Laurclavagh Renewable Energy Development Response to ACP FI reply from MKPO, Galway

Planning Reference: 319307

Date for Submission: 9th January 2026

Response to Further Information Laurclavagh Renewable Energy Development

Figure F15 Extract of N83 / L61461 junction with STOP line re-located to nearside of hard-shoulder.

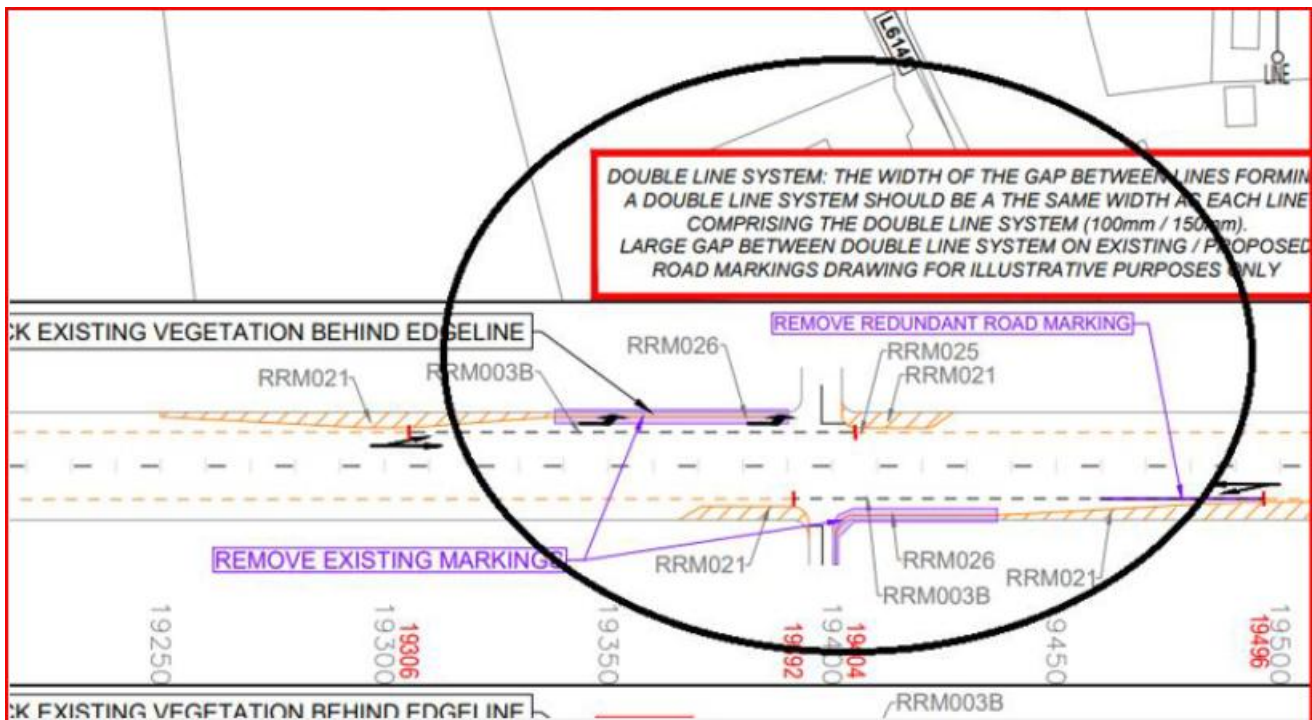
It is confirmed that there have been minor alterations made to the layout of the N83 / L61461 junction between the time of the preparation of the EIAR for the Proposed Project, and the date of the preparation of the Response to Observations Received Report, and the preparation of the response to issues raised by the Commission, presented in this report. The changes were implemented by the Donegal NRDO on behalf of TII, and it is confirmed that there are no further changes proposed. It is noted that the recent change to the junction layout, which includes the relocation of the stop line back to the nearside edge of the hard shoulder, does not include a setback of the boundary walls along the N83, which results in visibility for drivers accessing the N83 from the L61461 now being severely constrained. It is also noted, however, that this recently implemented design has been designed and implemented by Donegal NRDO / TII and its consultants, and is therefore accepted by the Applicant.

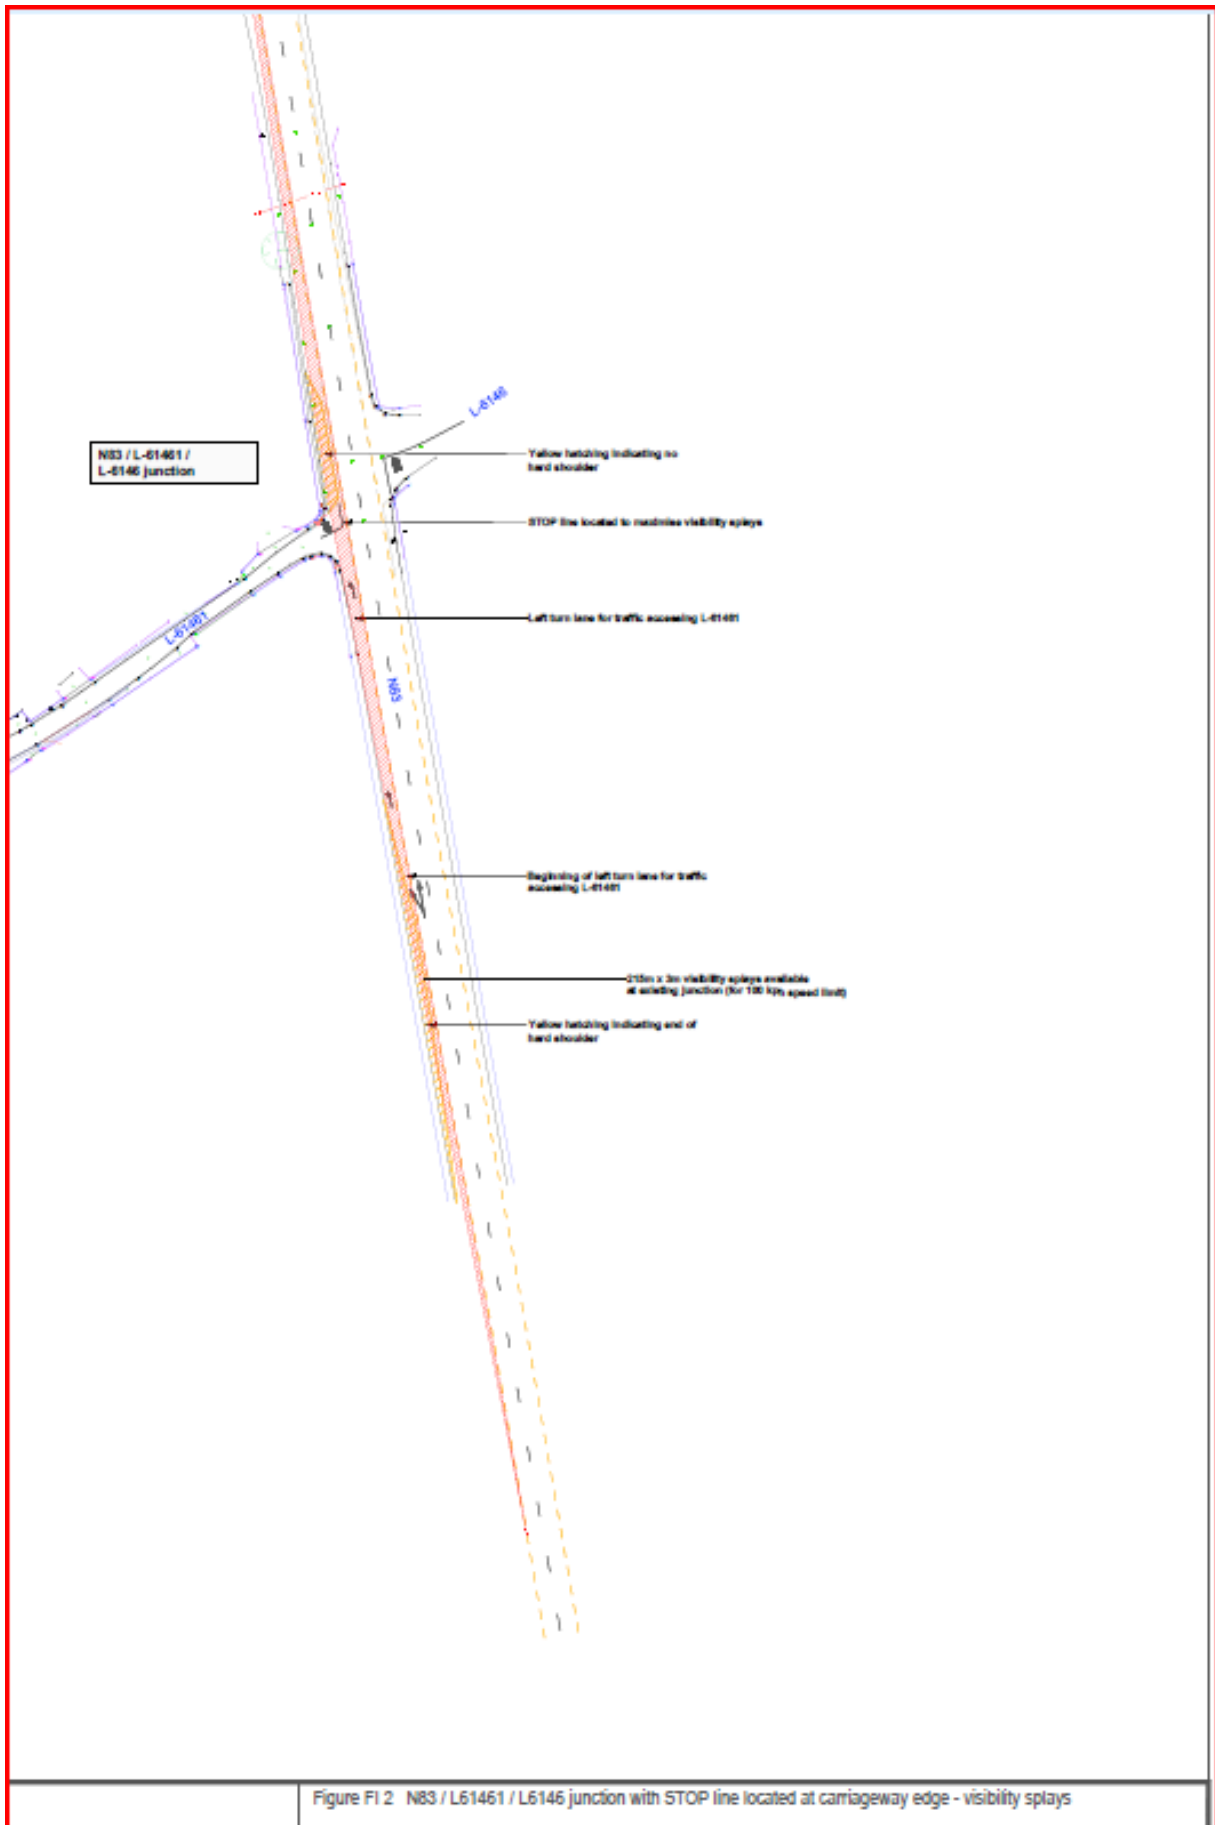
This layout does not comply with TII Standards

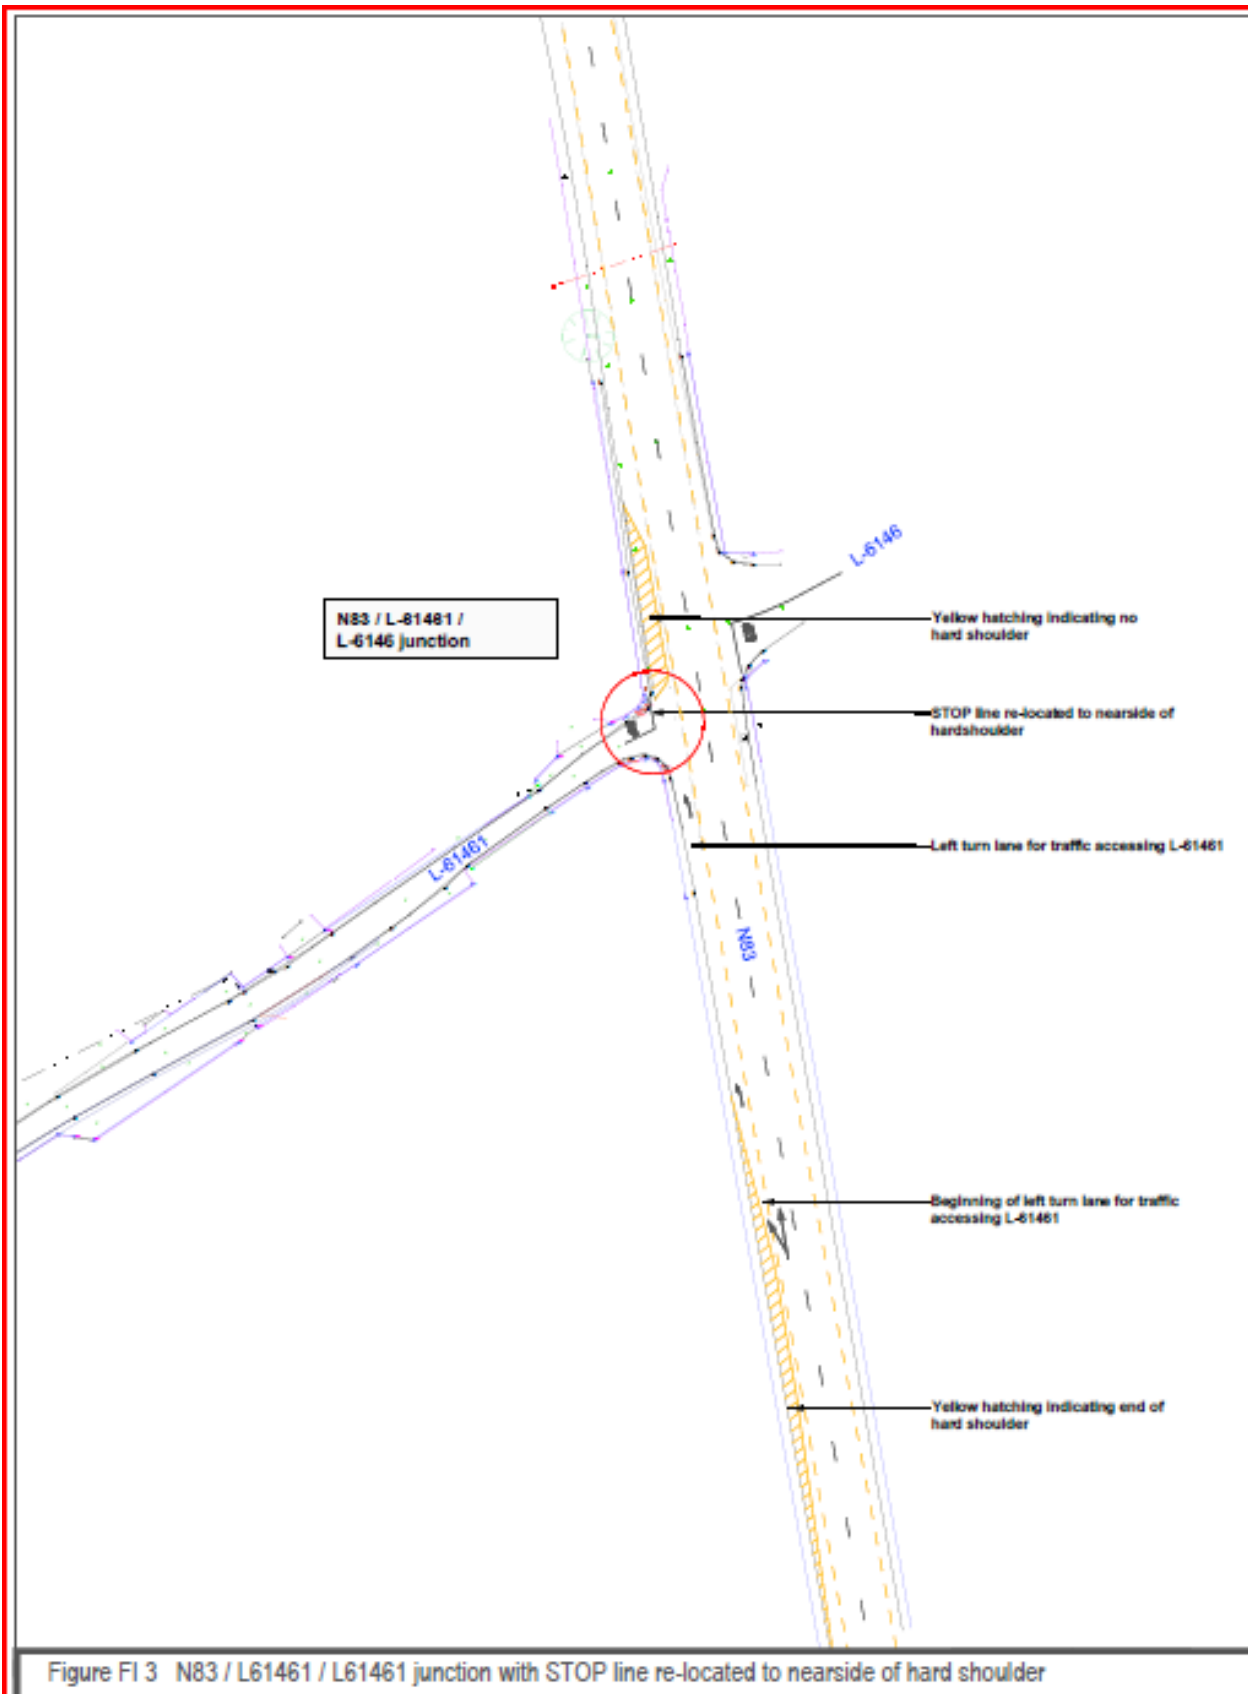
This layout does not comply with TII Standards

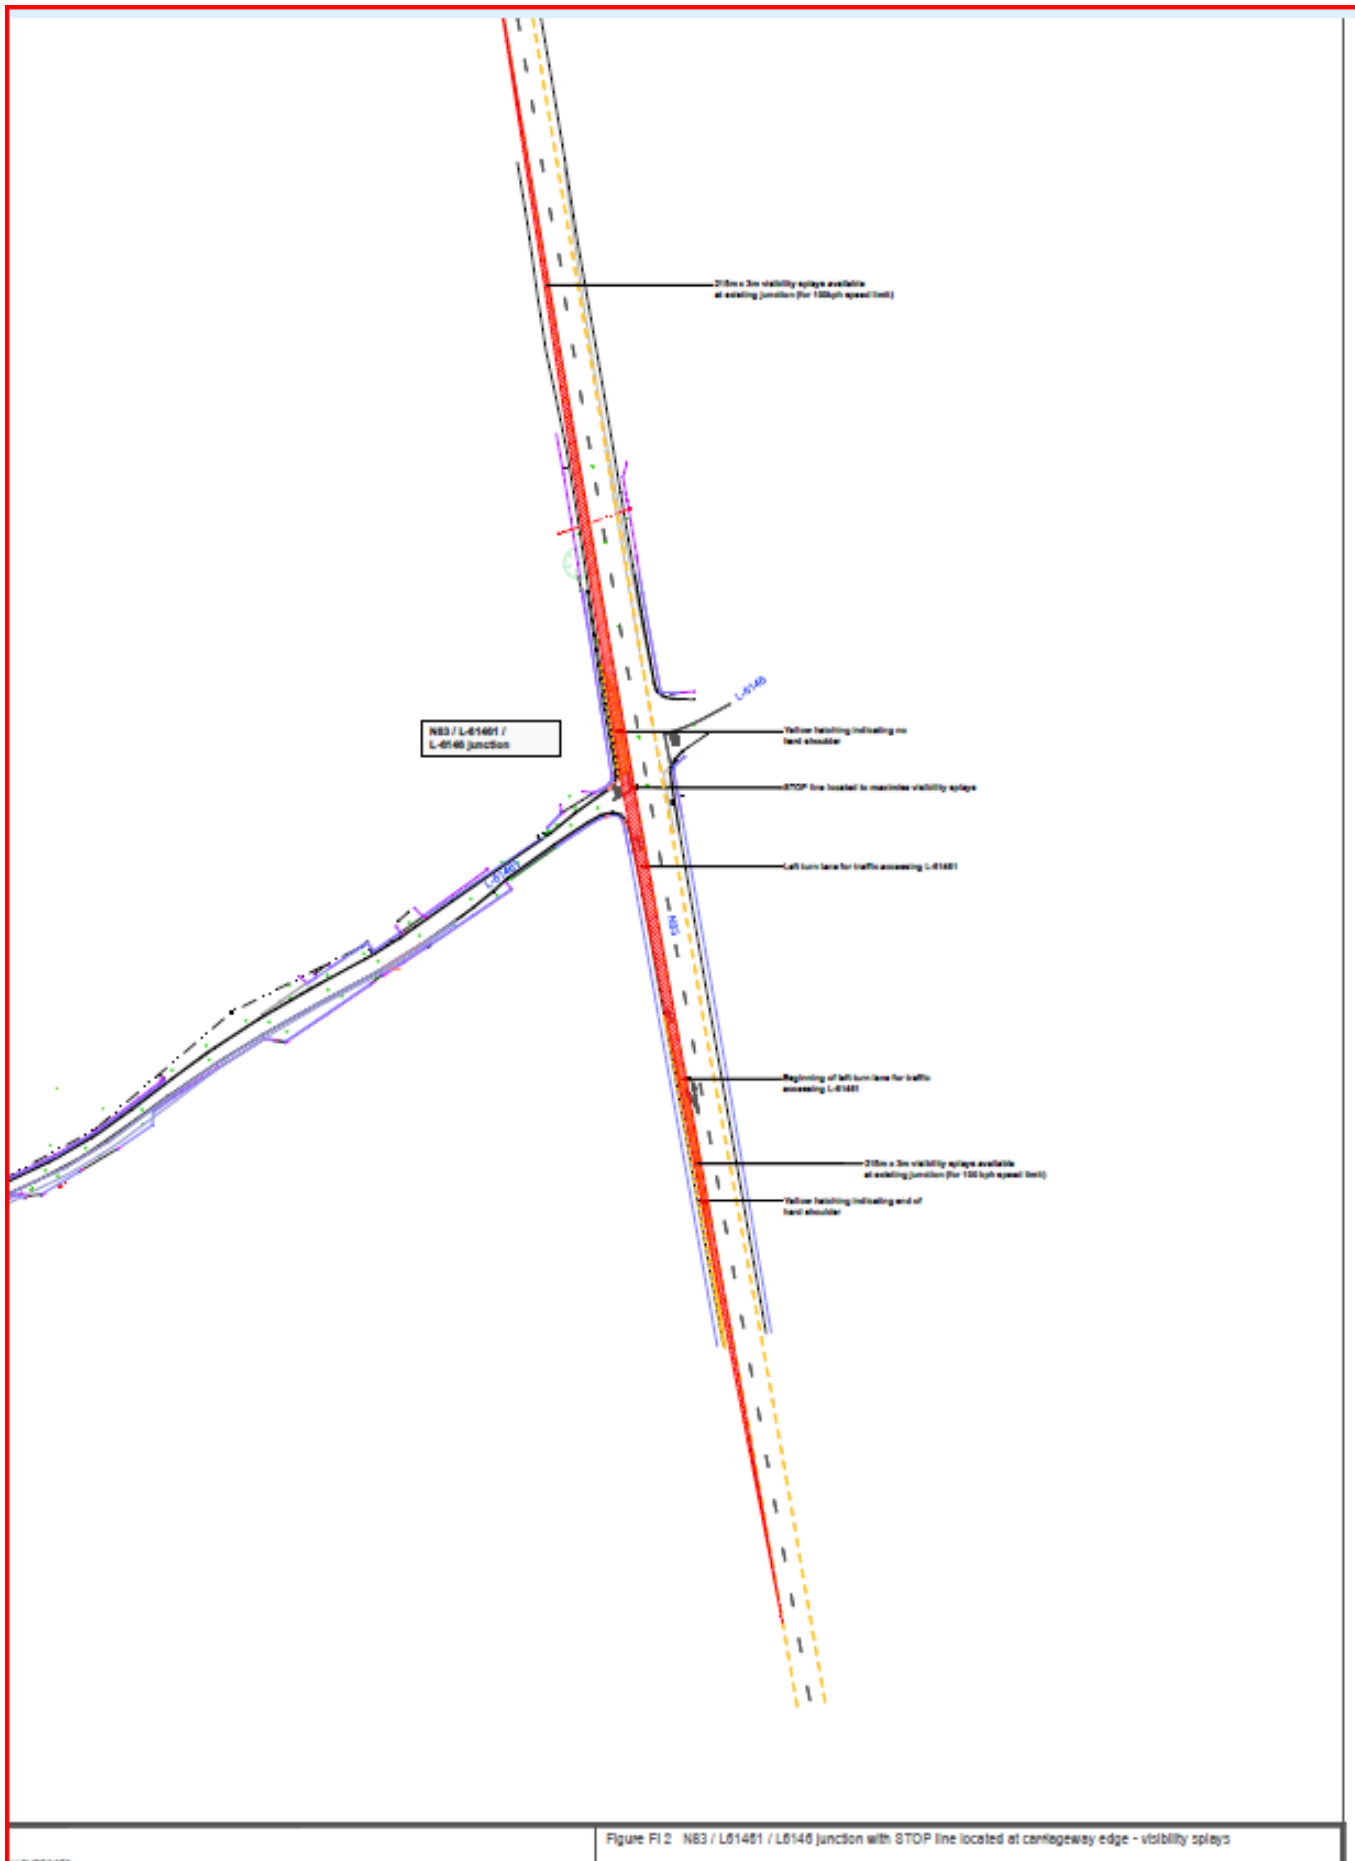
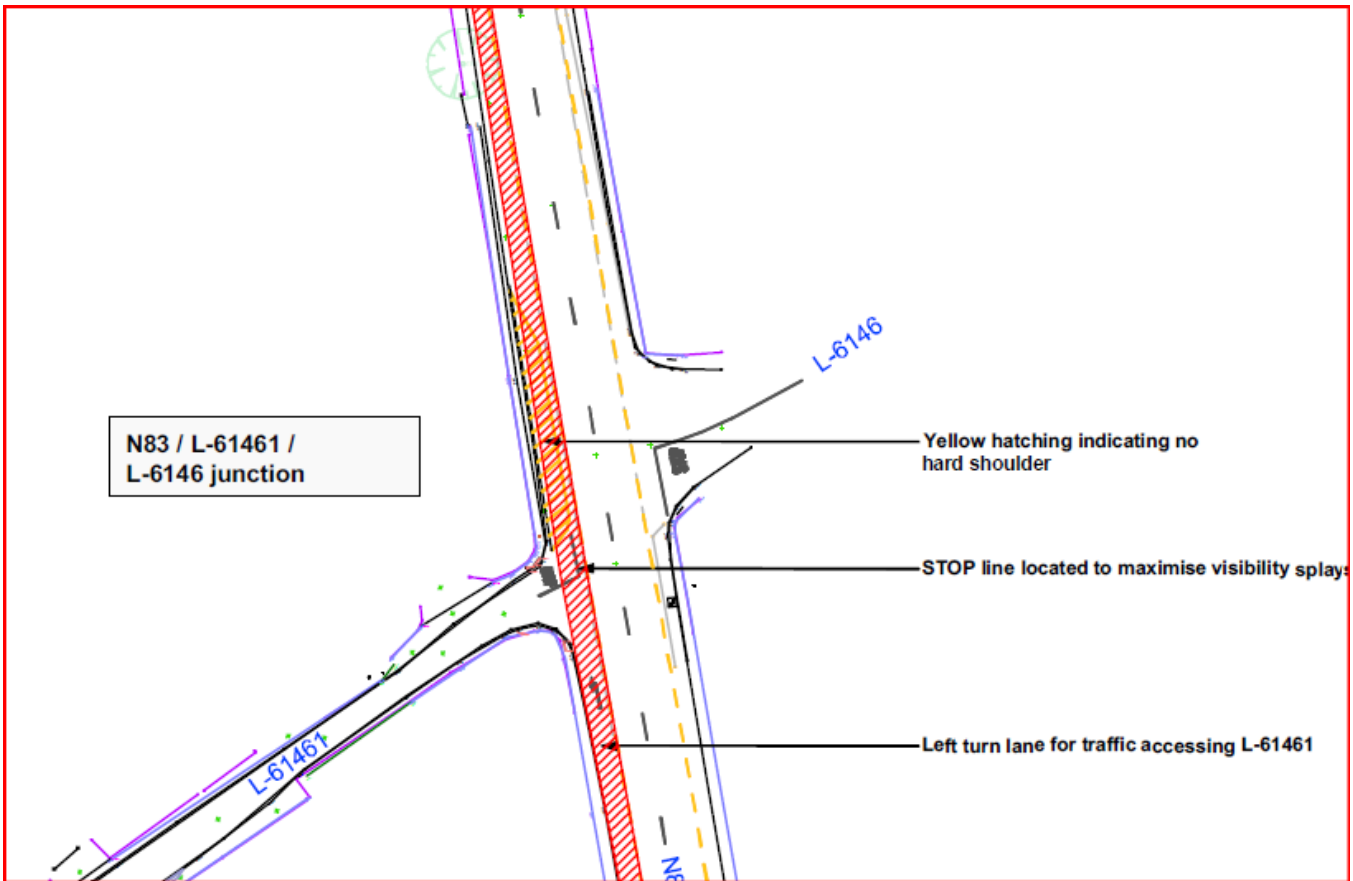
This layout does comply with TII Standards TII as National Roads Authority updated all existing junctions to reflect their adopted Standards for National Roads. This contract included the N83 Stop lines & hatched markings. The Stop lines & hatched markings at the N83/L61461 reflect the Standards.

Figure FI 3 N83 / L61461 / L61461 junction with STOP line re-located to nearside of hard shoulder

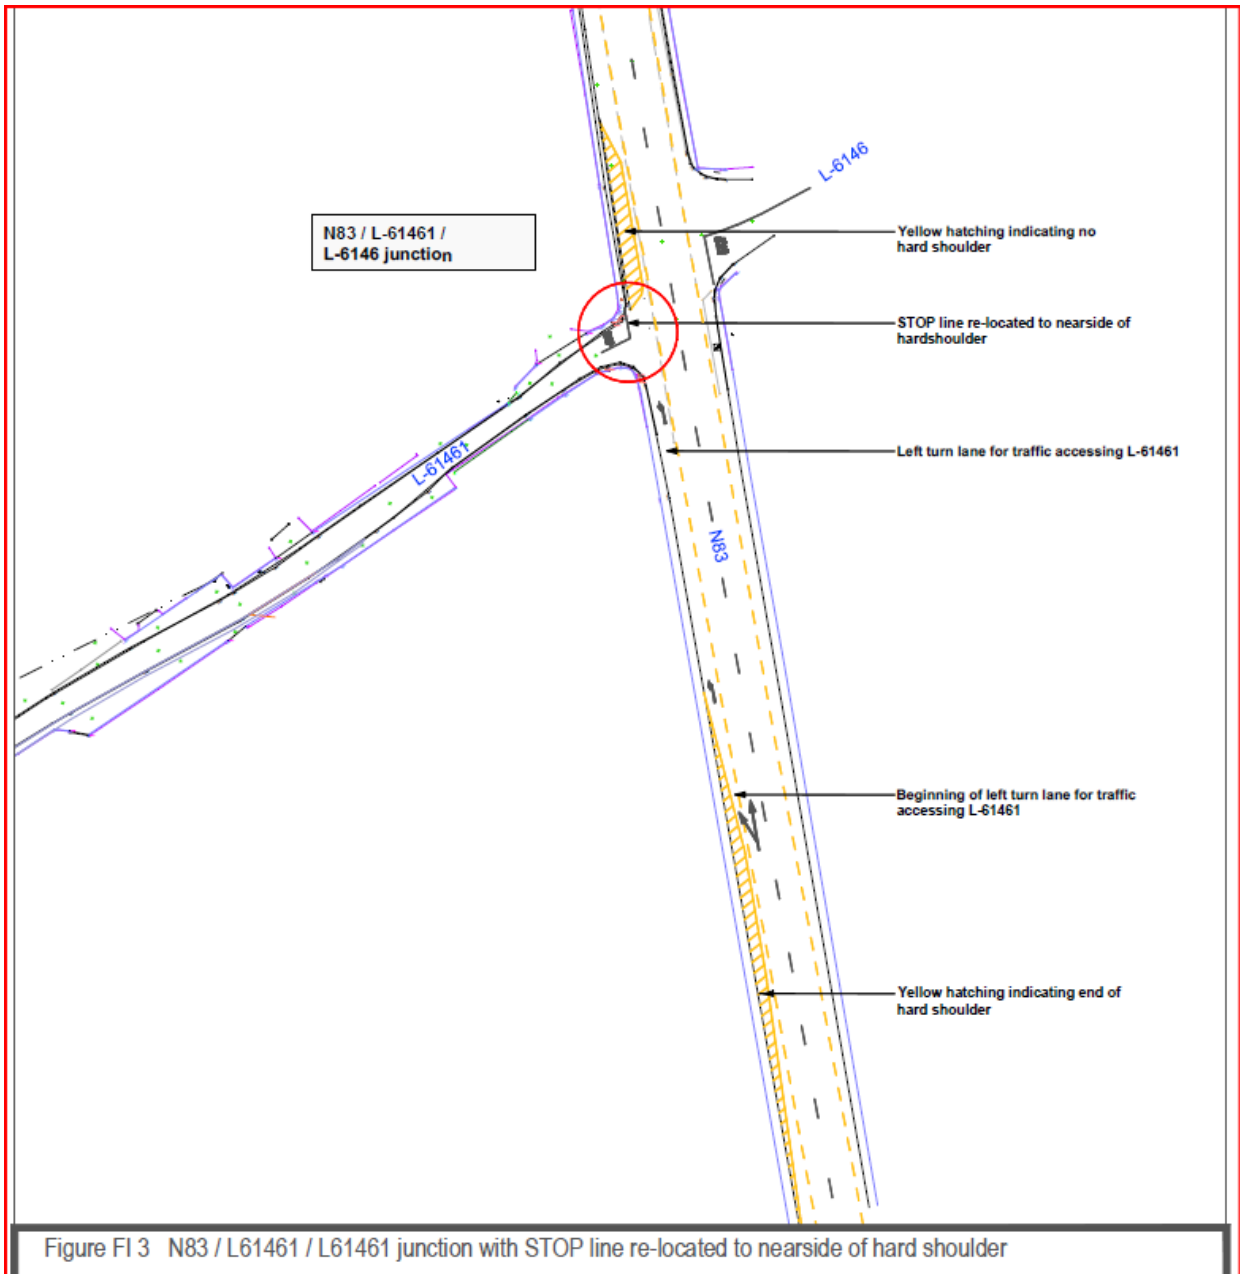
Note that the X distance should be 3m – 9m for Stop line control and not 2.4m. This crossroad is not a simple junction & no request for a relaxation from TII is indicated for a 2.4m X distance. This 3m minimum requirement reduces the Sight Distance Triangle to a lot lower than 35m & 20m. This is obviously why the Road Safety Auditor omitted mention of the junction issues. These SDT distances constitute a hazard to all traffic with rere-end shunts, head-on collisions and side-swipe accidents. It would constitute gross negligence to grant Planning Approval for such a proposal.
